MULYI-LANE HYBRID OPTION – analysis and recommended design.

Keene City Council – MSRP Meeting – 07/12/2023

The following observations and recommendations are based on the Multi-Lane Hybrid Option provided by STANTEC at the July 6th Keene City Council Meeting.

Cross Walks - Lights and Turn on Red

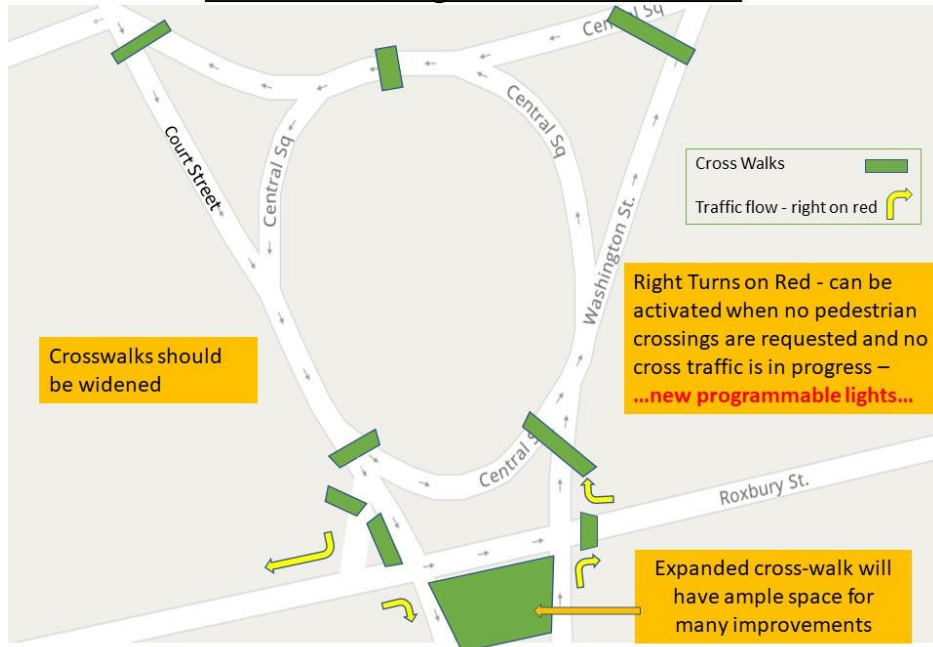
Attached are diagrams showing the square and turning options and the Gilbo Ave intersection.

Note: If there are no pedestrian crossings require the next cycle can begin early.

Change Traffic Flow – Make room for Expanded Cross Walks
